Service Bulletin

Subject: Intermittent Heat Failure in LOV/OCF/ FilterQuick Fryers

THIS BULLETIN REPLACES BULLETIN 2012-07. REMOVE 2012-07 FROM YOUR FILES.

MAY 14, 2015

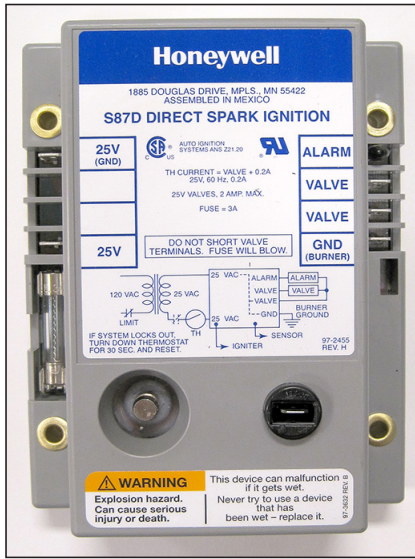
8. Reference the parameters of the four different ignition modules pictured on pages 3 and 4. Ensure that your optimal UA output does not greatly exceed the published levels. In 30 pound fryers, more micro amps are not always better. If micro amp readings are elevated, it may necessitate reducing the blower air shutter until the flame turns blue, then re-opening the shutter to the point that the burners go infrared. Monitor the fryer thru several cook cycles to ensure the settings are correct..

2000-04/2015 End of Production,
Fall 2015 End of Service Part

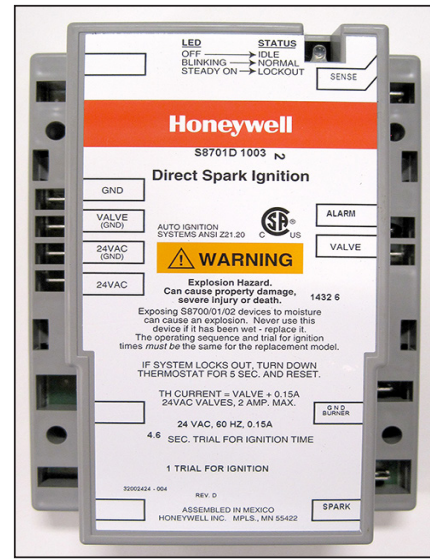
Replace with kit 8263271.

A hardware upgrade kit 8263270 for GL30 frypots (LOV and OCF) is required for each frypot to initially replace with the new Capable Control modules. One 8263270 will accommodate two 8263271 kits.

Use	Domestic
Spark Outputs	Single
Fused	No
Lockout	0.6
Optimal UA output	2.5-3.5

**2000-04/2015 End of Production,
Fall 2015 End of Service Part**

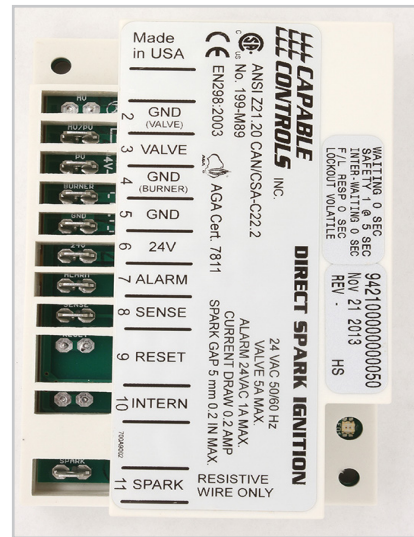
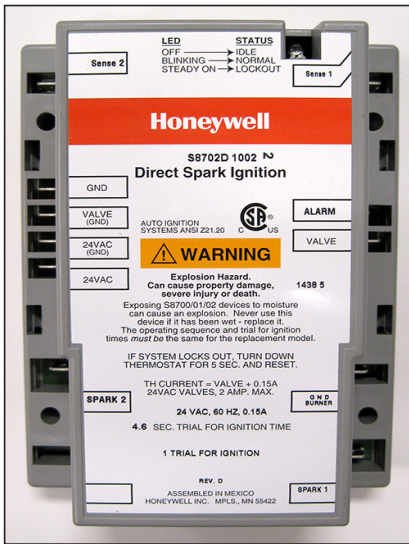
Replace with kit 8263272 (includes 2-Single Spark modules).

A hardware upgrade kit 8263270 for GL30 frypots (LOV and OCF) is required for each frypot to initially replace with the new Capable Control modules. One 8263270 will accommodate one 8263272 kit.

Use	All
Spark Outputs	Single
Fused	No
Lockout	0.15
Optimal UA output	0.4- 0.8

Use	Domestic
Spark Outputs	Dual
Fused	No
Lockout	0.6
Optimal UA output	2.5-3.5
